MEMORANDUM

Bendix
Computer

SUBJECT: Errata

EXPLANATORY NOTES ON ECO #1096

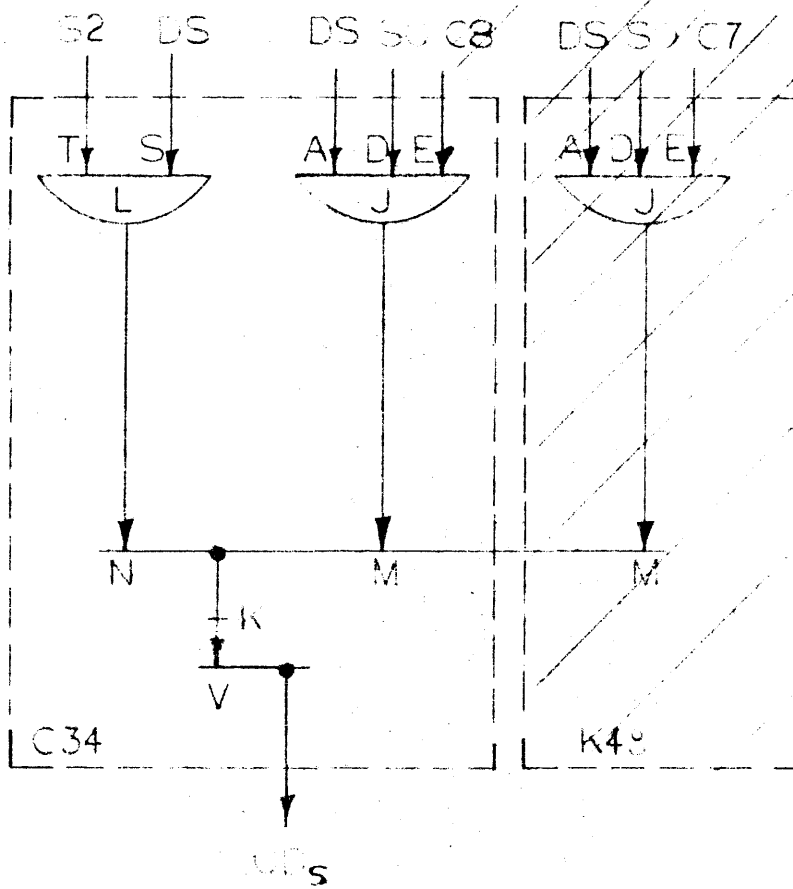
To insure reliable operation of the G-15 input-output system in the standard mode, "READY" is now used to reset the AS (Automatic-Standard reload) flip-flop. This means that if an automatic mode input is going on, it is necessary to wait for "READY" (or give the "Set Ready" command) before initiating a standard mode input or output. If the neon is on, S must be typed before Q or P to gate numeric type-in or photo tape read, respectively. (See figure 1)

FIG. 2

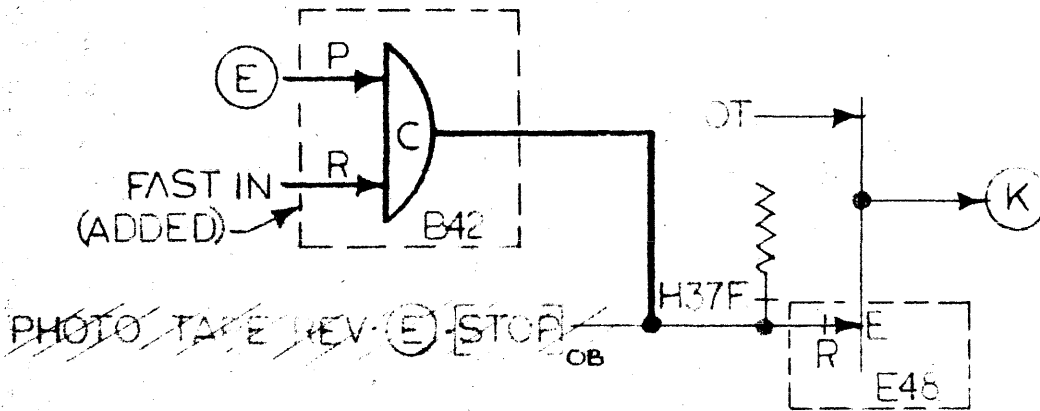
A modification was recently made to allow blank leader on the MTA-2 without causing a precession of M19. Since machines with serial numbers less than 210 do not contain this change, it is not desirable to write programs using this feature. Therefore, the modification was removed and the diodes used to clean up other signals. (See figure 2)

FIG. 3A

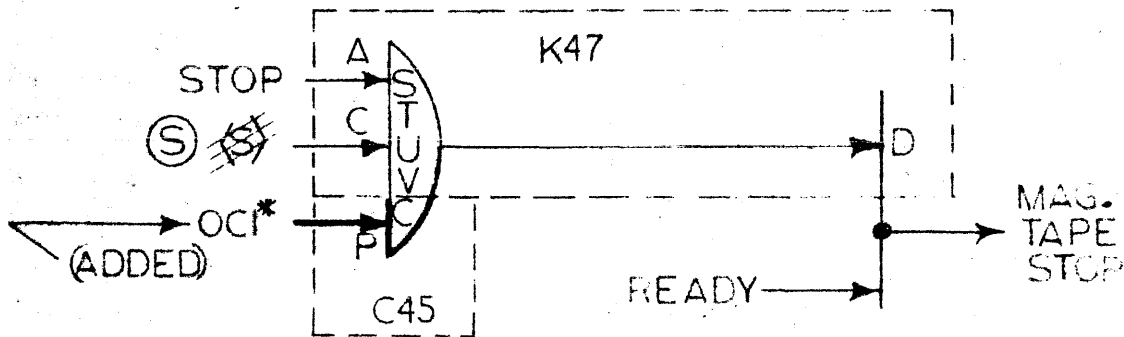
Erroneous stop codes will no longer be encountered during acceleration of magnetic tape when starting in the midst of data. Also, approximately 60 ms. of overshoot was added on searching magnetic tape in reverse for stop codes. This was done since the MTA-2 stops so quickly in this mode that the stop code is sometimes missed in a following forward operation. (See figure 3)

TO CAUSE OVERTHOOT ON MAG. TAPE REVERSE.
 NOTE: THE CHANGE OF (S) TO Ⓢ IS NOT A LOGIC CHANGE BUT THE CORRECTION OF A DRAFTING ERROR.

FIG. 4

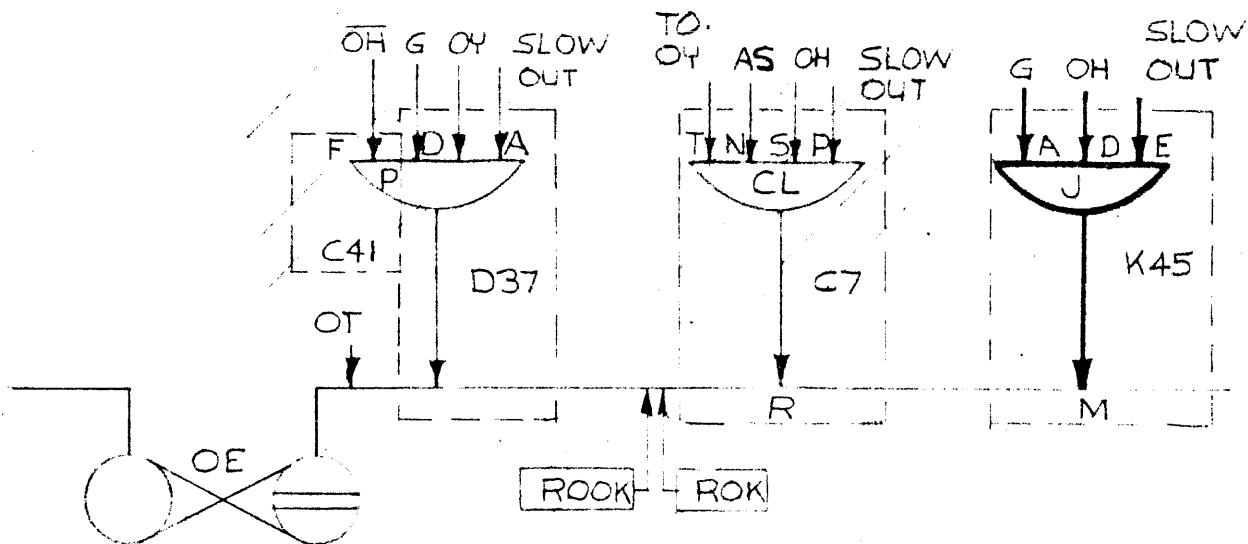
It was logically possible for a simple type-out of AR to cause a four-word precession of M19, although cases of this happening were few.

However, further qualification of C by [STOP]_{os} eliminates this possibility. (See figure 4)

FIG. 5

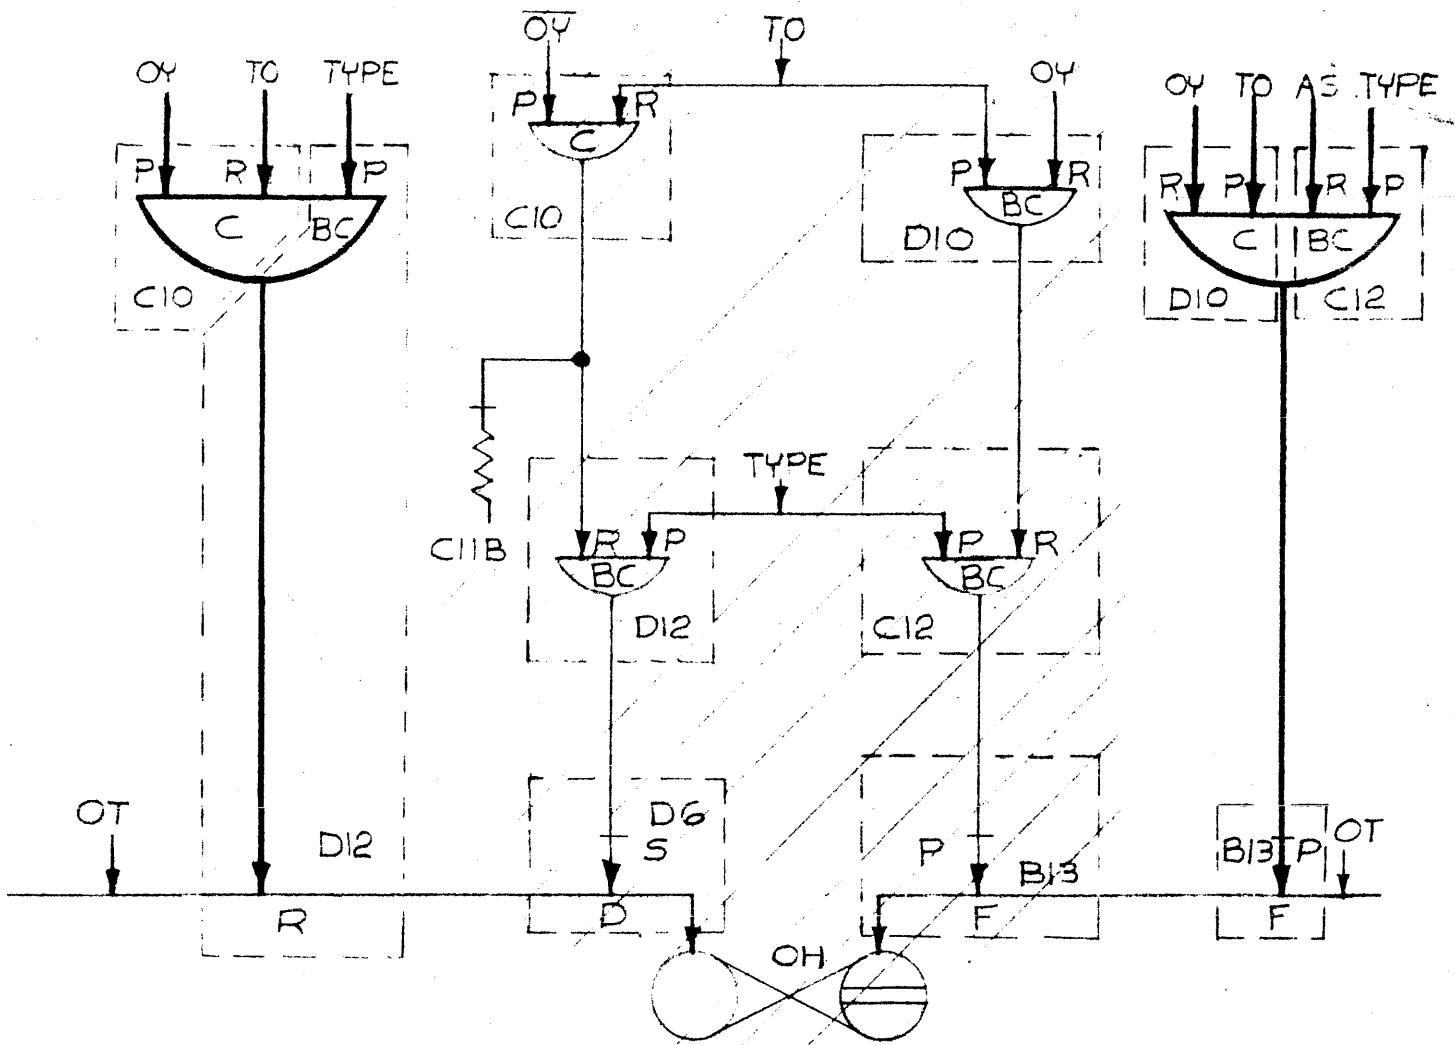
The slow out timing logic was revised to make it more reliable and to use

less components. The big changes were to remove the fake feedback loop involving the HC Buffer-inverter and qualifying the setting of OH with AS so that OH would not be used during numeric type-out. (See figures 5, 6, 7, and 8)

FIG. 9

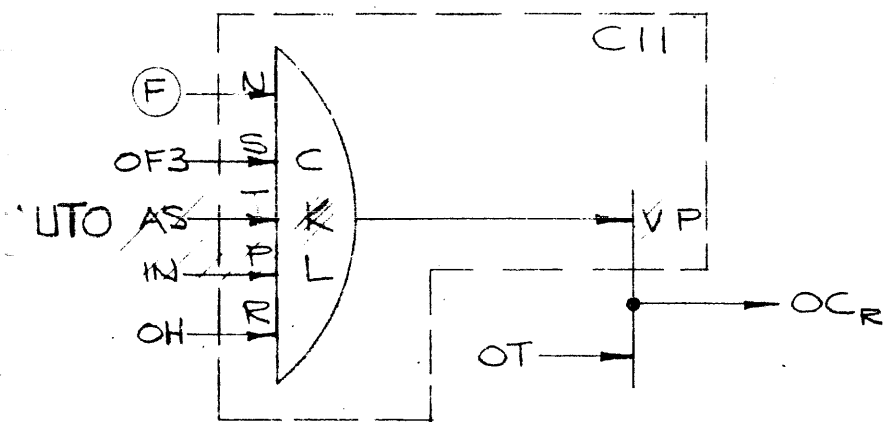
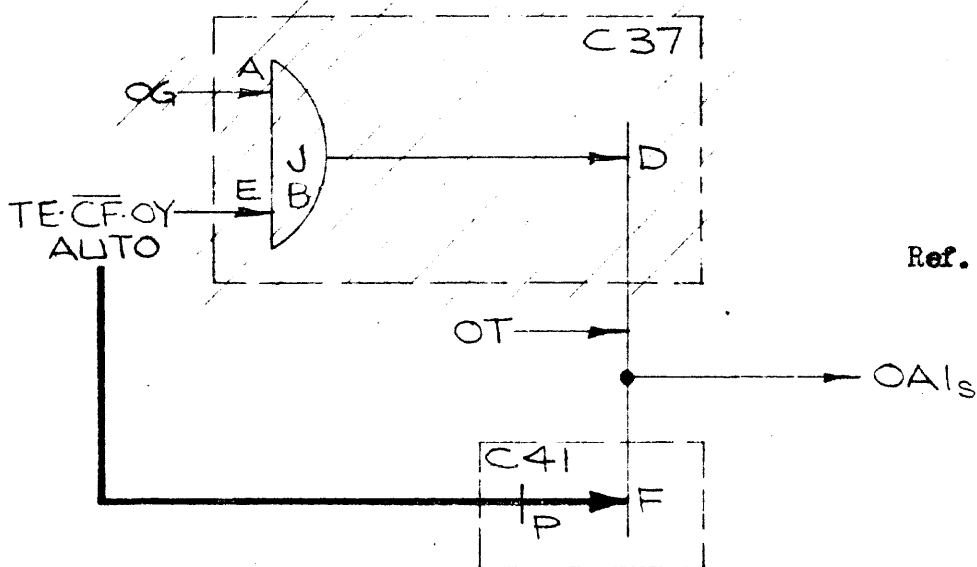
To simplify the logic and use less hardware, many redundant terms are removed. (See figures 9, 10, and 11)
